Design Review Board

5.A [26-0371](#) Case: Capital Pet Urgent Care, 26-1210

Case: Capital Pet Urgent Care, 26-1210

4950 HARRISON AVE NW
OLYMPIA, WA 98502
LAND USE SUBMITTAL

6A ENLARGED SITE PLAN
1" = 20'-0"

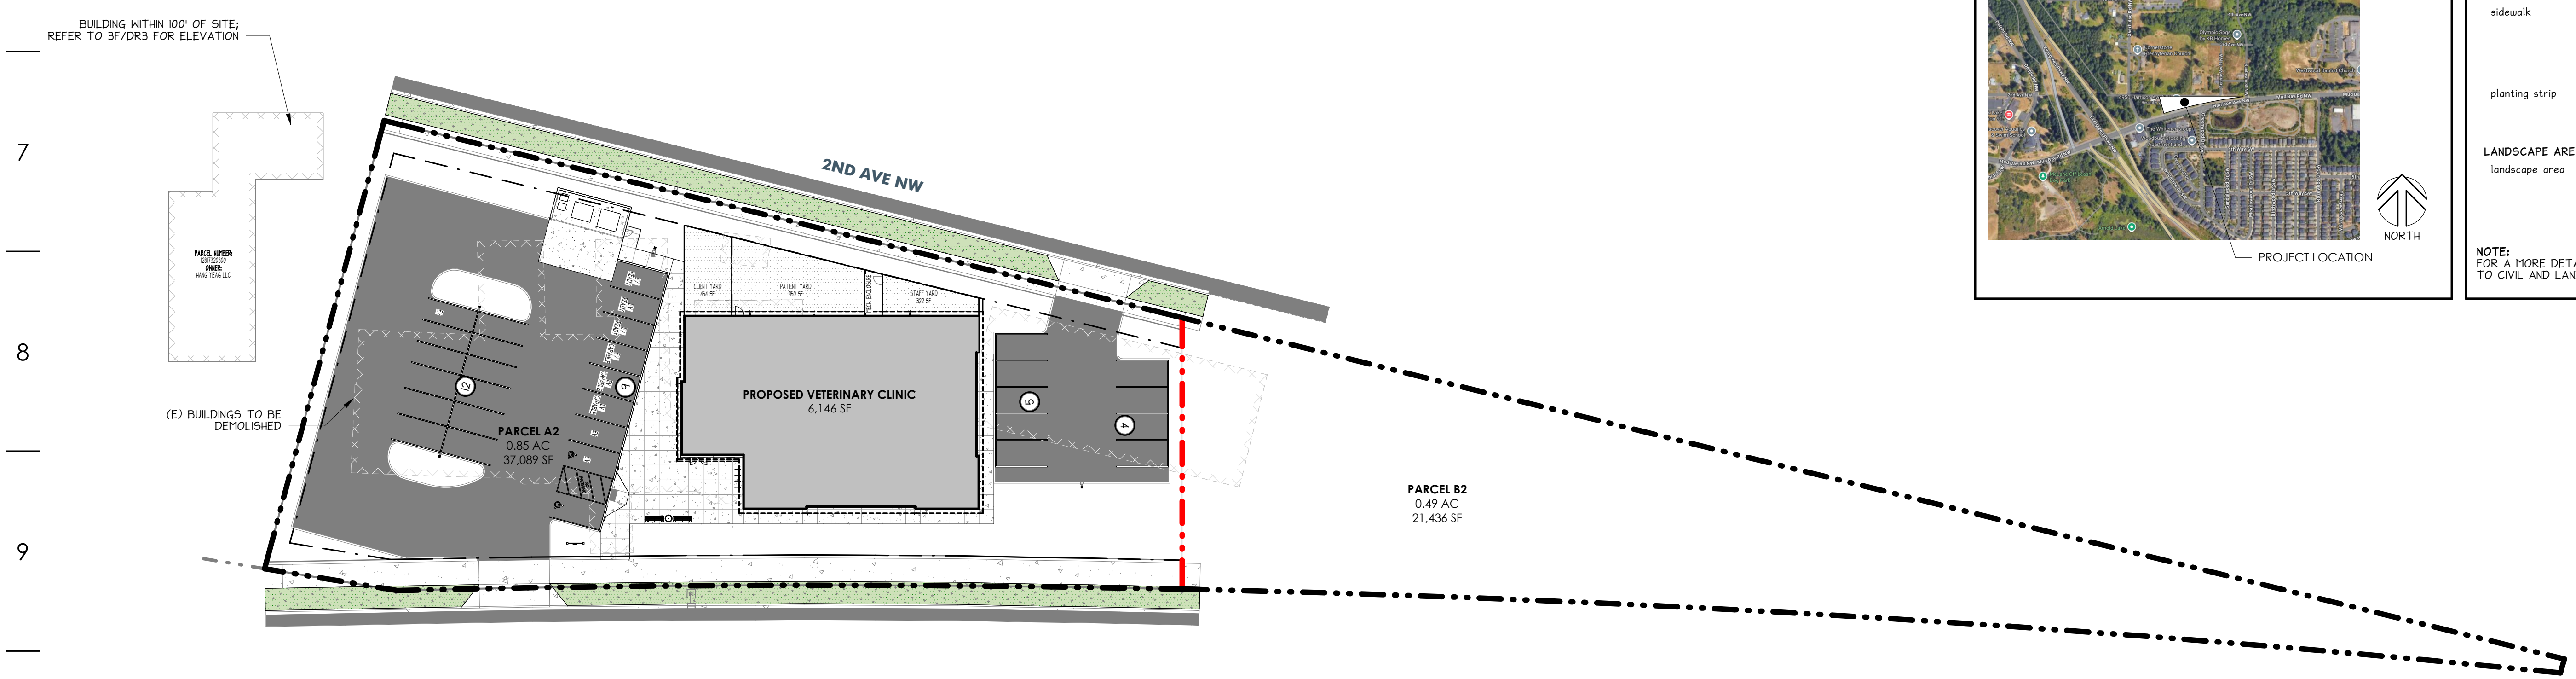
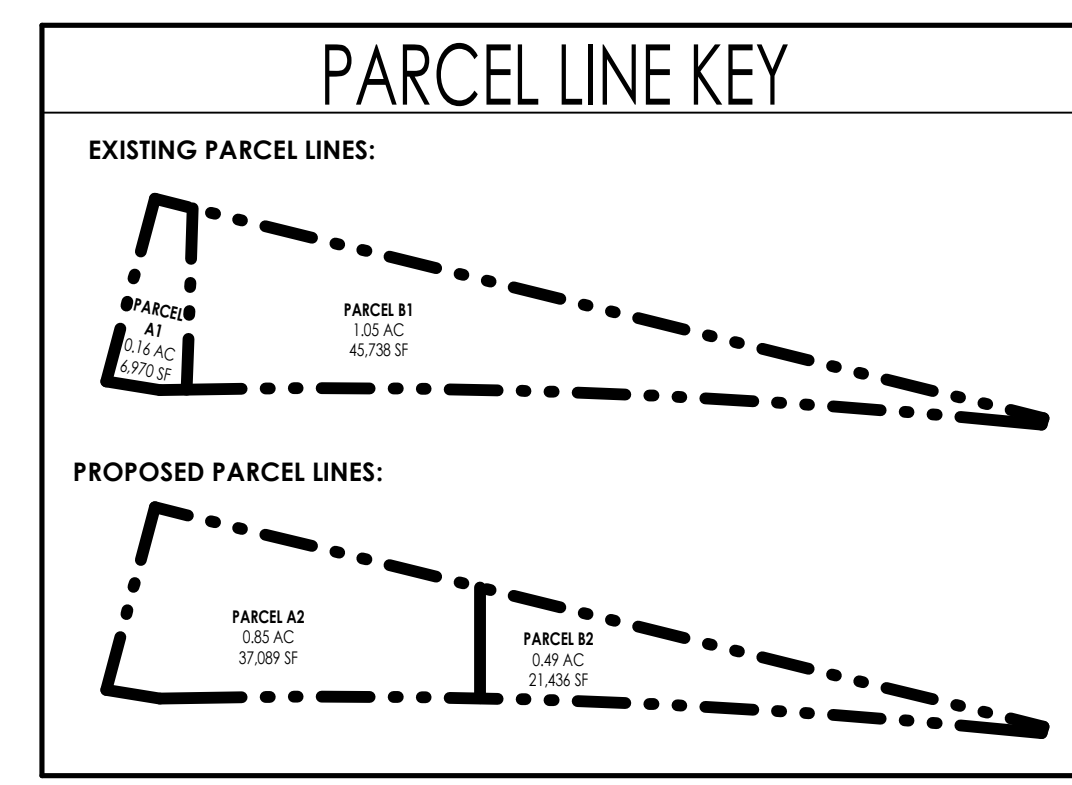
Staff Response: The proposal provides pedestrian amenities with seating, landscaping, patterned walkways and bike racks. However, the Board should be aware that the short-term bicycle racks as proposed are not adequately covered to protect them from weather. To provide enough weather protection coverage it is likely the applicant will need to extend the roof overhang or provide an awning above and beyond the bike racks by 1 ½ feet. It is not anticipated that this would be a significant change to the front façade that affects design review elements. The Board could discuss whether there are concerns over such change.

Staff Response: Per OMC 18.110.010, the building cannot be brought up to the street per the setback requirement. Parking is located on both sides of the building. The entrance is clearly articulated and obvious from the street.

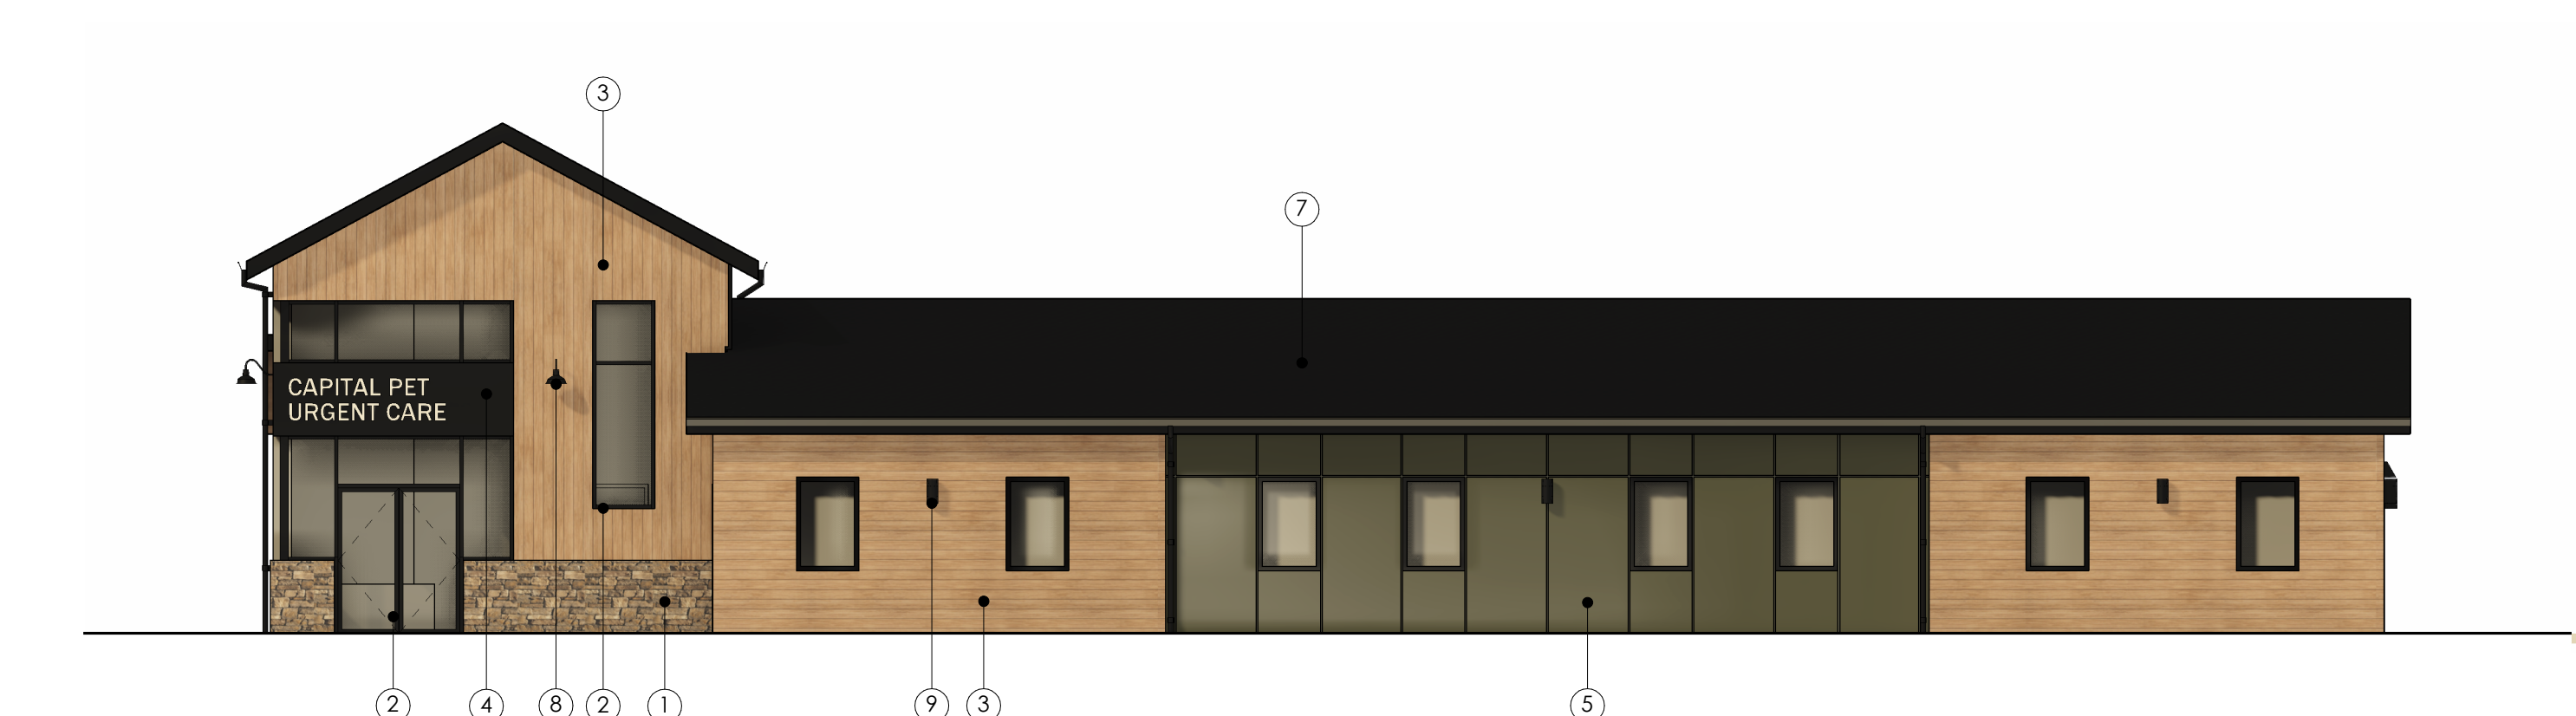
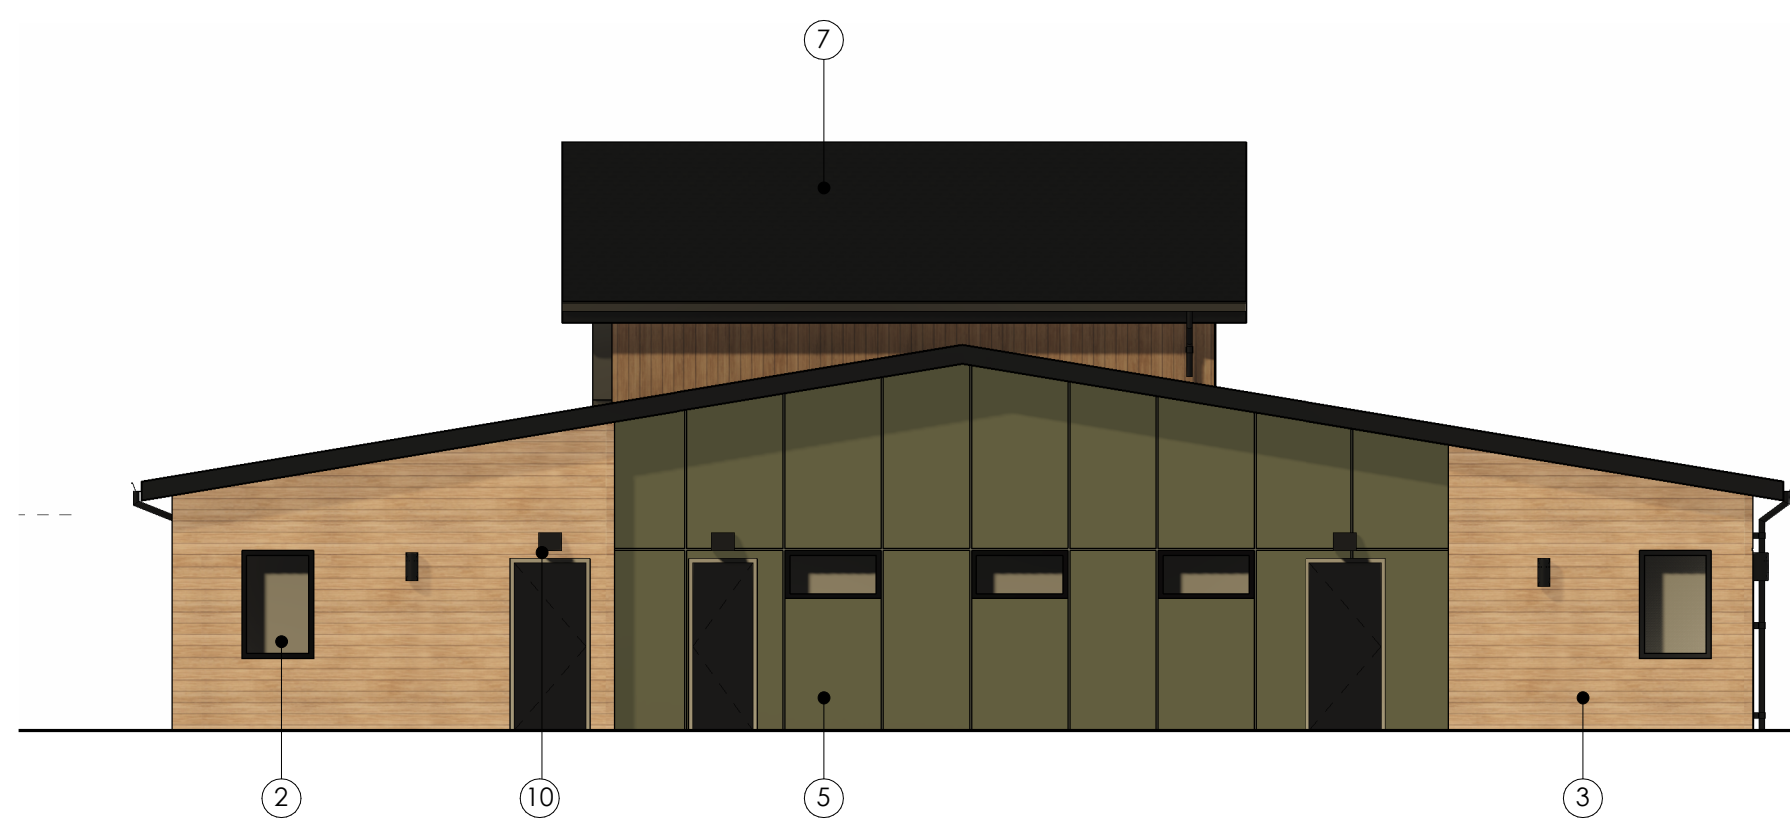
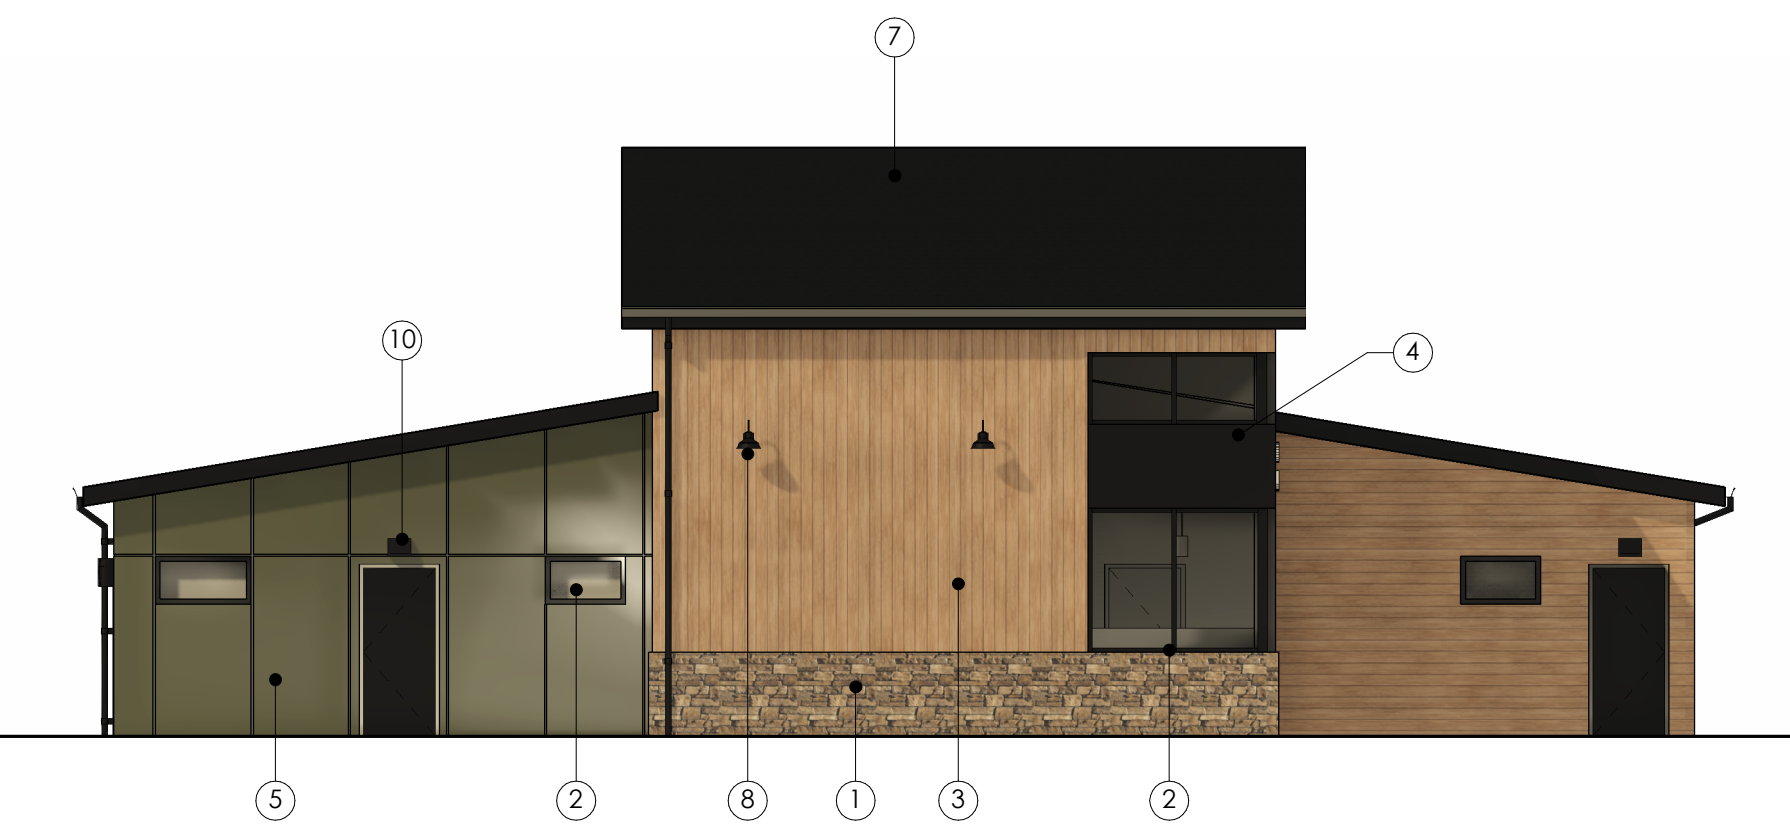
Staff Response: It appears that the applicant is proposing to substitute glazing for other building elements to meet requirement as the glass is not comprised of 60% of the building face. Staff identified the following:

- Exterior architectural details through use of different exterior materials are being used on the building but the mid wall section exceeds 30 feet in length. It is interpreted that wall segments should have different architectural details, such as material changes every 30 feet in length.
- No landscaping or climbing plants are proposed adjacent to the building and screening of the wall that is over 30 feet is not achieved.
- A pedestrian area is being provided upon at the southwest entry point adjacent to Harrison Avenue with landscaping and seating benches.

Staff Response: The south façade of the building has a portion of the wall that is over 30 feet in length and has no adjacent landscaping or other elements that provides any screening to this portion of the wall. The recommended suggestion by staff to add landscaping along the south wall under 18.110.090 Street Walls would also provide compliance with this requirement. A condition within the staff report has been added for the Board.

- Context Plan:** Approve as proposed
- Site Plan and Landscape Plans:** Approve with the following condition:
Provide the final landscaping plan at time of civil engineering and show that additional landscape screening materials adjacent to the south wall that is over 30 feet in length has been provided, for compliance with 18.110.090 and 18.110.200.
- Building Design, including Detail Elements, Lighting, Material and Colors:** Approve as proposed.

PRELIMINARY LANDSCAPE PLAN

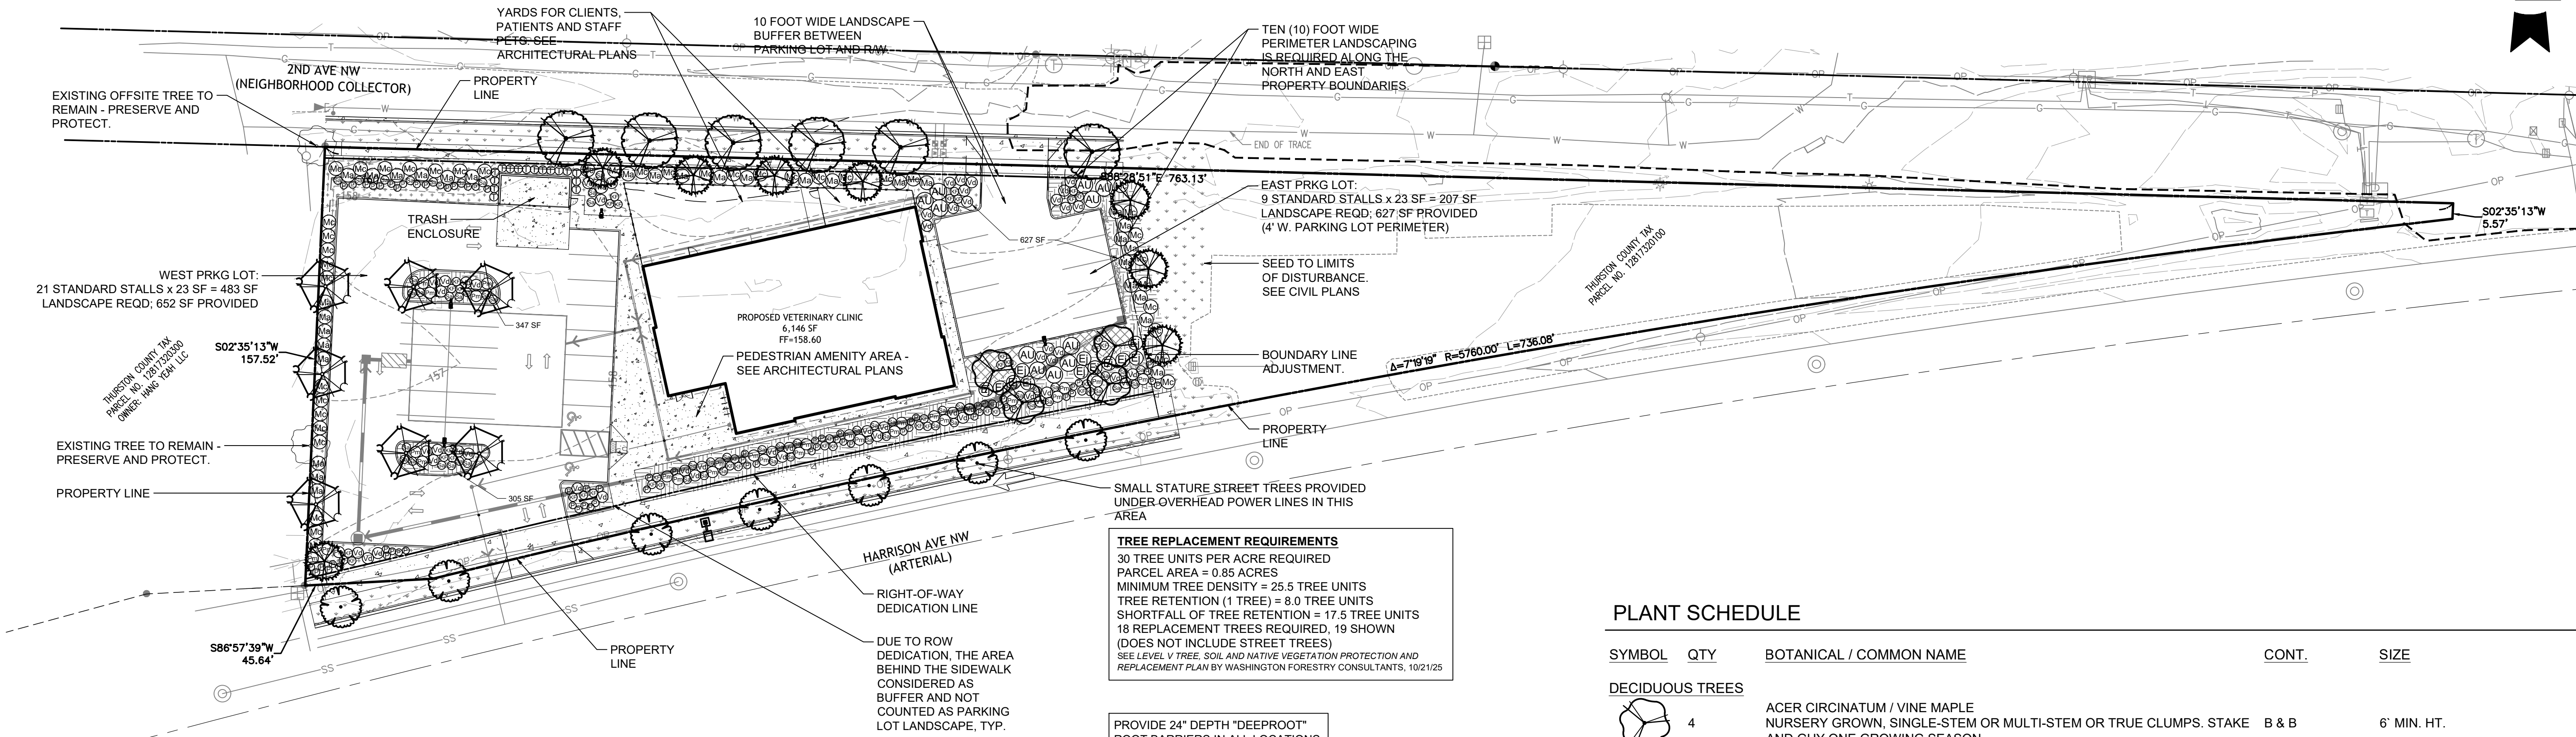
Staff Response: The landscaping plan shows compliance with this section, but the site needs additional trees planted to meet land use requirements for parking lot landscaping and perimeter landscaping. Staff will review final landscaping plan at time of civil engineering permit review.
